## MEMORANDUM

**REVIEW TYPE:** Preliminary Plan of Subdivision

**APPLYING FOR:** 2 lots for 2 one-family detached residential units

**PROJECT NAME:** Brookmont  
**CASE NO.** 120060430  
**REVIEW BASIS:** Chapter 50, Montgomery County Subdivision Regulations

REVISED  
PRELIMINARY PLAN OF SUBDIVISION

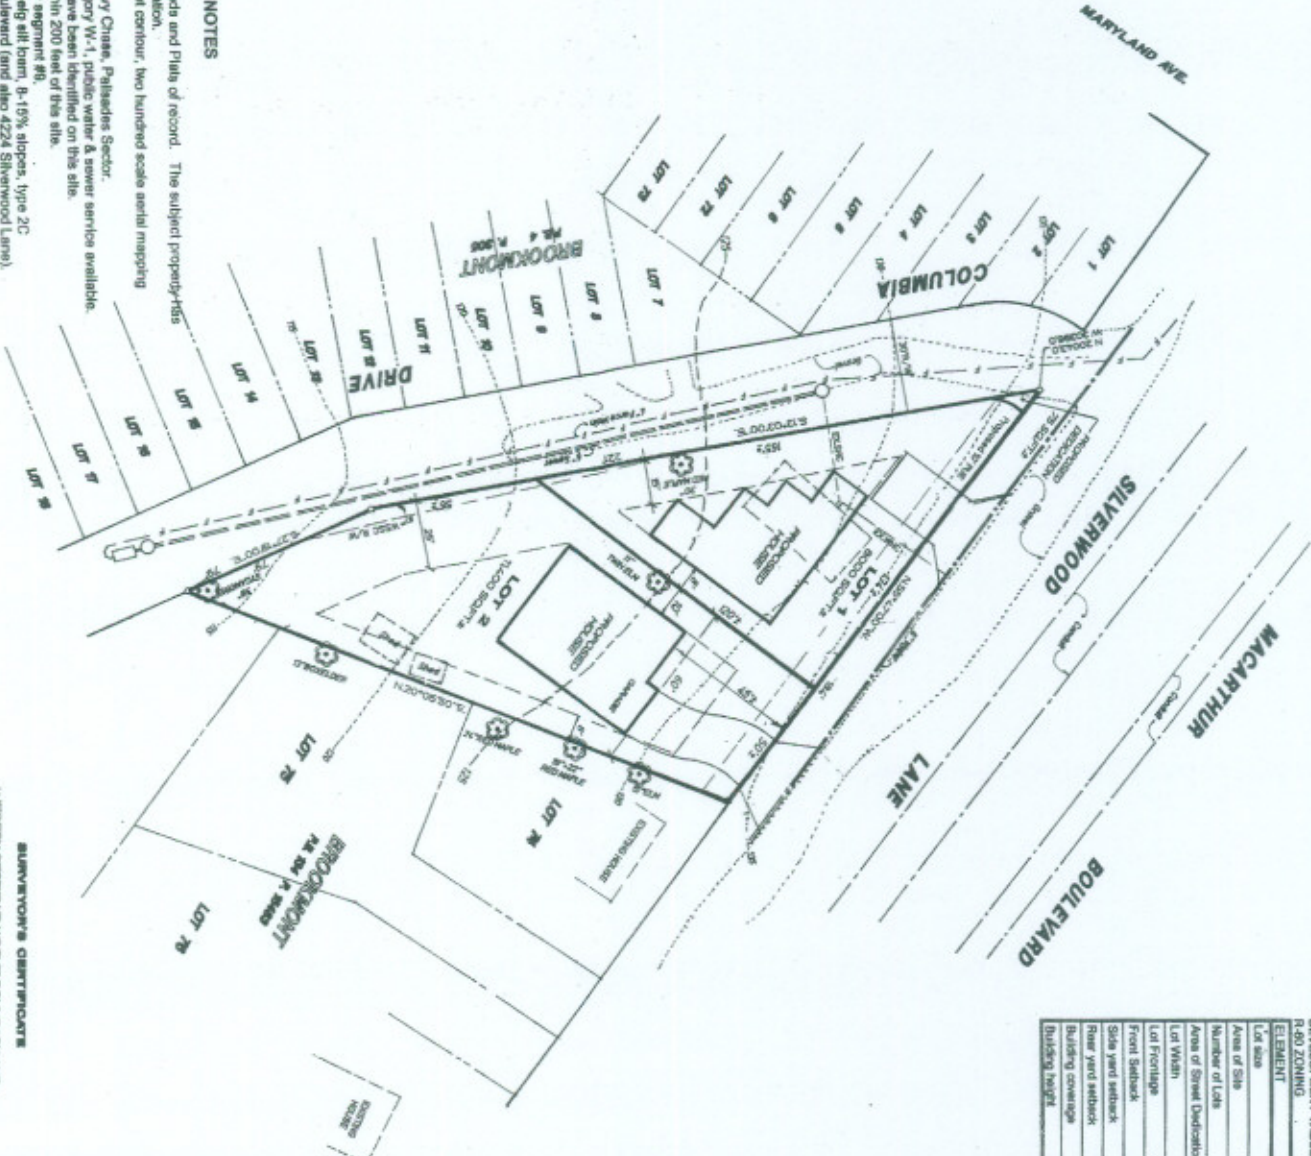
Property owners adjacent to the parcel, as well as other residents of Silverwood Lane have raised concerns, which we share, as to whether the proposed dwelling meet setback and height requirements, especially in light of the recent ZTA 03-27 changes. The proposal, in the best light, barely meets permissible limits.

Our Civic League's land use and development committee also has concerns about the drainage and sewerage on the property. Currently, there is a single, small house on the parcel. The property is an acutely triangular patch of land with graveled roads on two sides. The smaller of the two roads angles steeply downwards to the Brookmont Park and playground where our community already has serious drainage and erosion problems. The outfield of our ball park, for example, turns into a swamp for days at a time because the drainage channel at its perimeter fills with silt within months of being dredged.

In response to your question related to the proposed houses, it is normal not to have specific house plans with the detail you reference until there is an approval and all of the development related issues are established. But, you should be assured that the proposed houses and development of the property will conform to all zoning setbacks, height, building coverage and use requirements.

Concerning your drainage, erosion and sewerage concerns, we have visited the site with Amy Lindsey, of the MNCP&PC, Environmental Planning staff. Based on our observations the existing drainage problems with the community's ball field, down grade of this site, are the result of several factors. None of which it appears this site has any liability for except to develop responsibly in conformance with all runoff and sediment control regulations as required by Montgomery County Code.

The only erosion observed in the vicinity of the ballfield was at the outfall of the ball field's enclosed drainage system where the pipe and pipe outfall are failing and in need of maintenance and repair.

Sewer for the proposed homes will be connected to the existing public sewer main in the Columbia Drive.
